COUNTY OF GALVESTON, TEXAS

BLUE HERON DRIVE IMPROVEMENTS

PROJECT NO. BV01

ADDITION # 1

PROJECT TITLE: BLUE HERON DRIVE		PROJECT ID: BV01
DRAWN BY:	SHEET DESCRIPTION:	SHEET NO: 4 / 30
CK'D BY:	GRADING DETAIL	
SCALE:	APPROVED BY:	
DATE: 9/10/2020

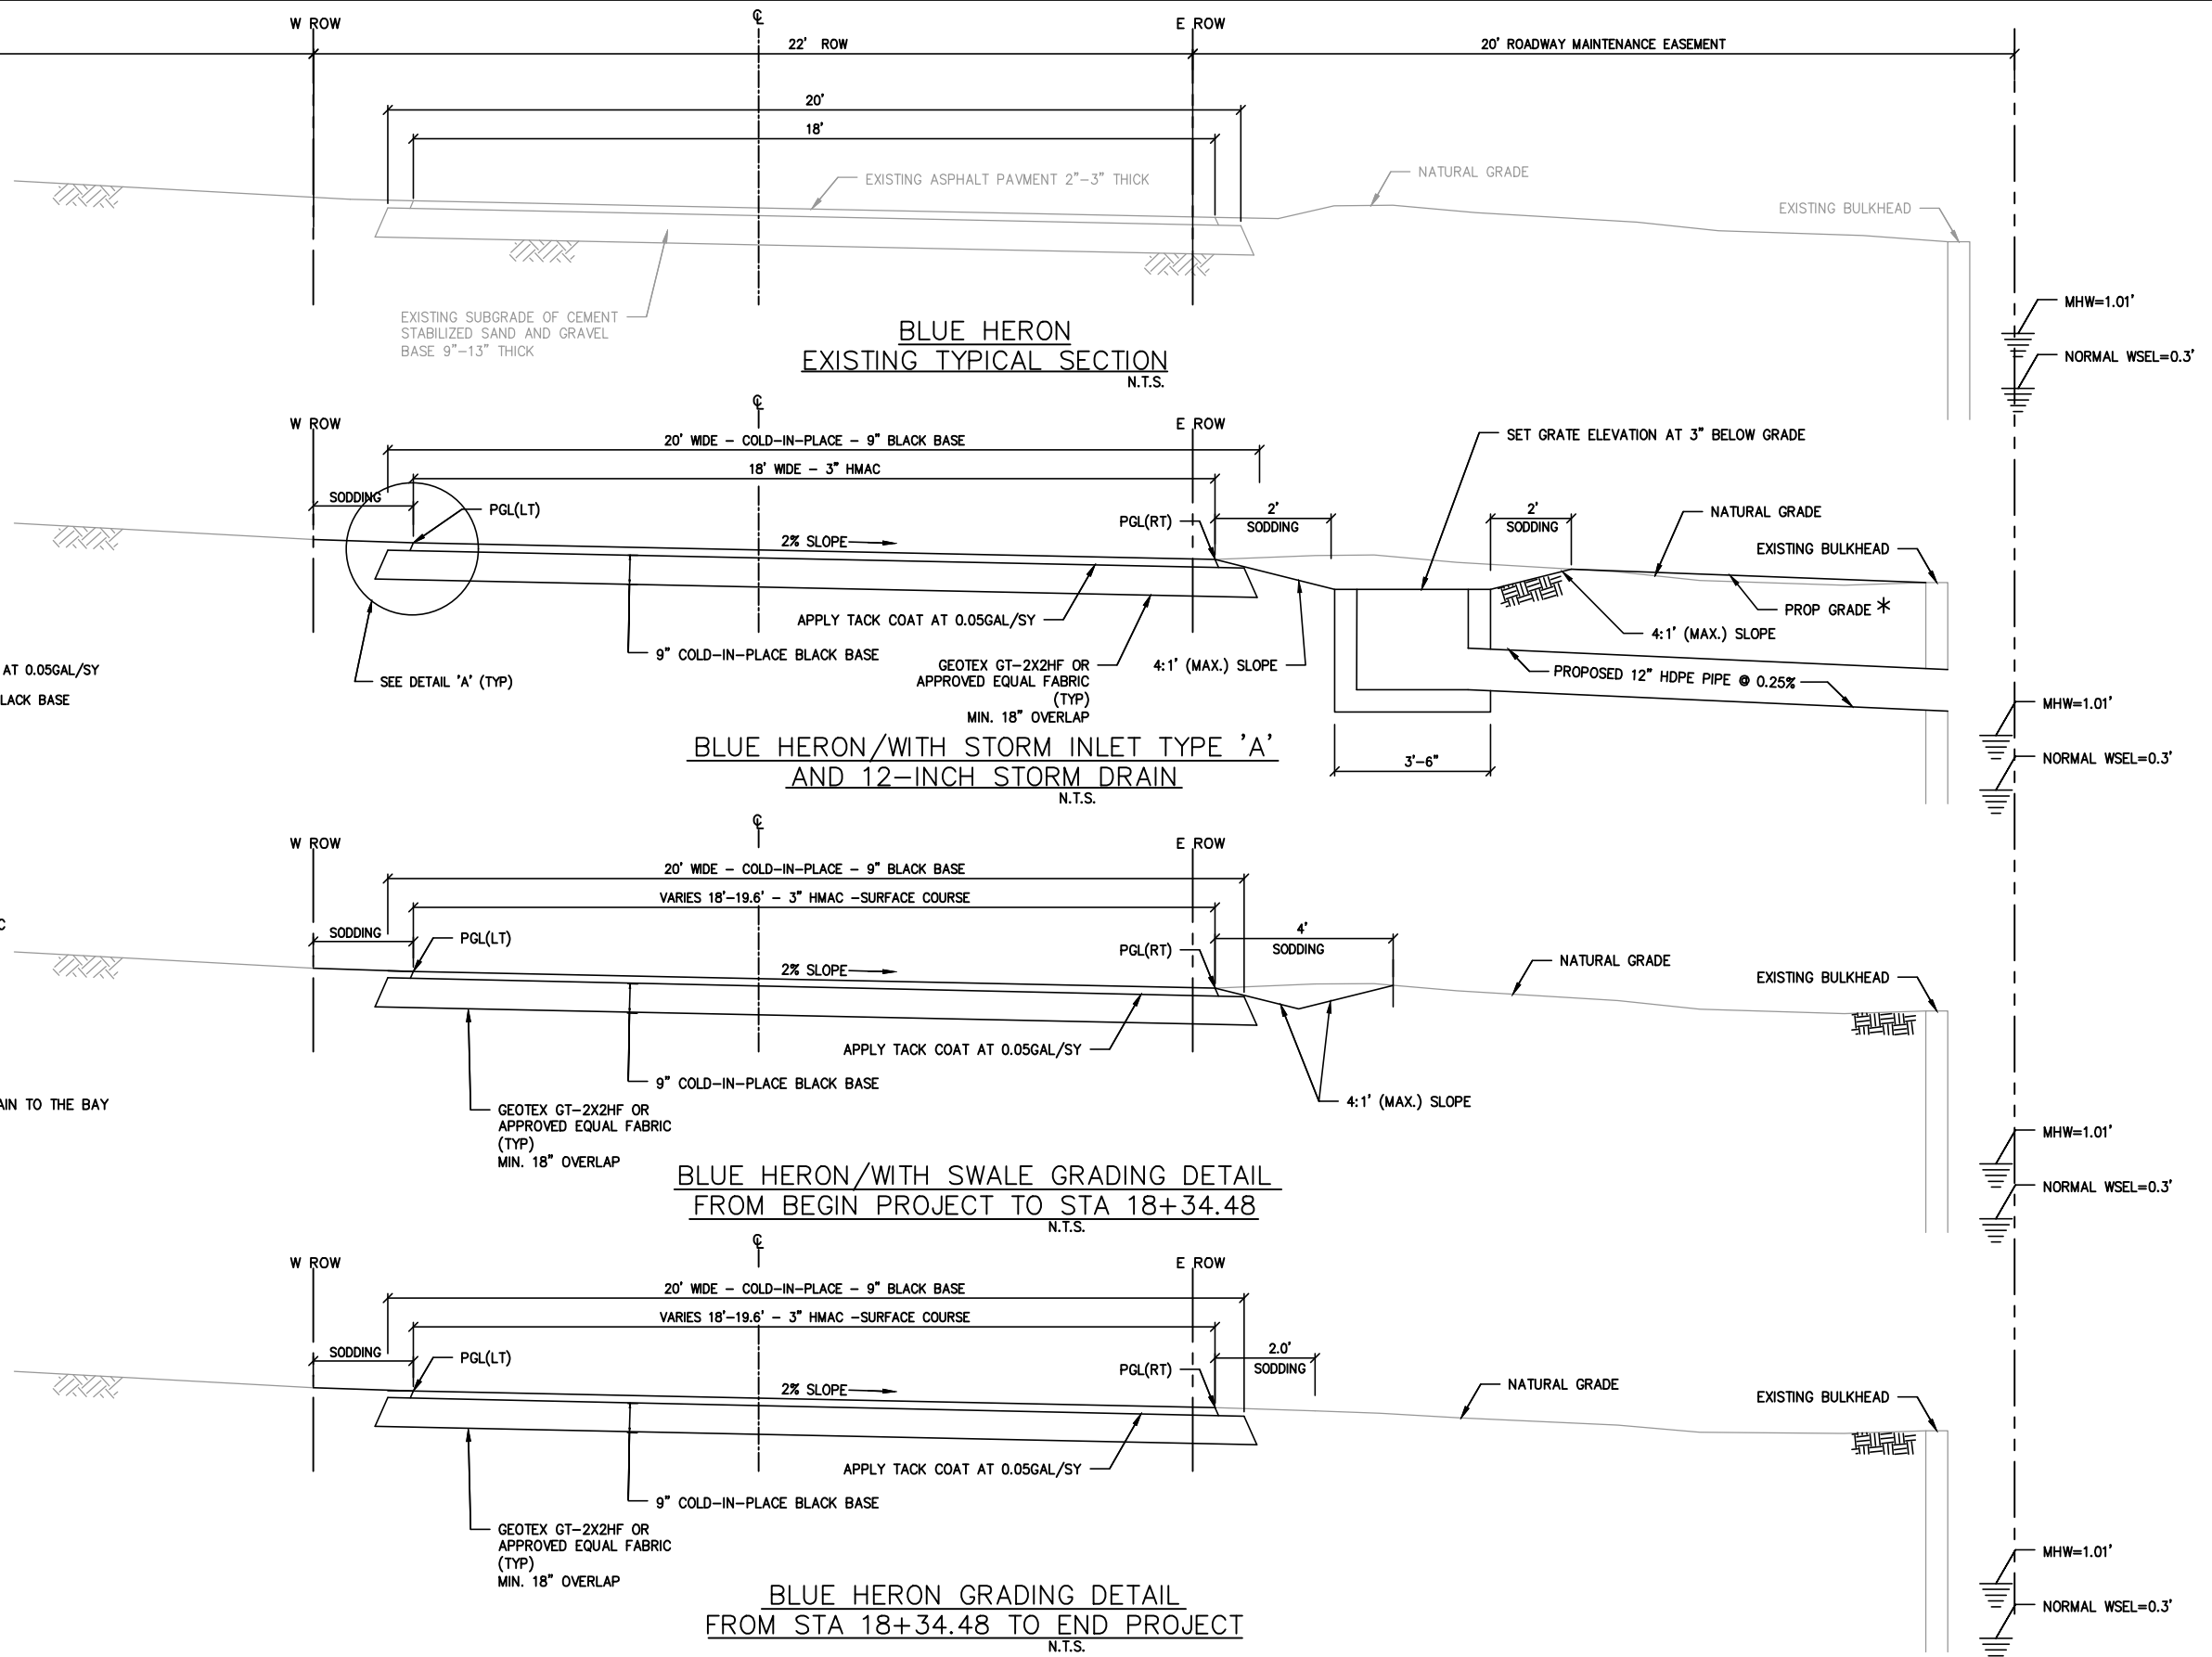
1. *Sheet No. 2 - Added Alternate Typical Section for Concrete pavement*
2. *Sheet No. 4 - Replaced call outs for '9" cold-in-place black base' with '9" cold-in-place recycled base.*
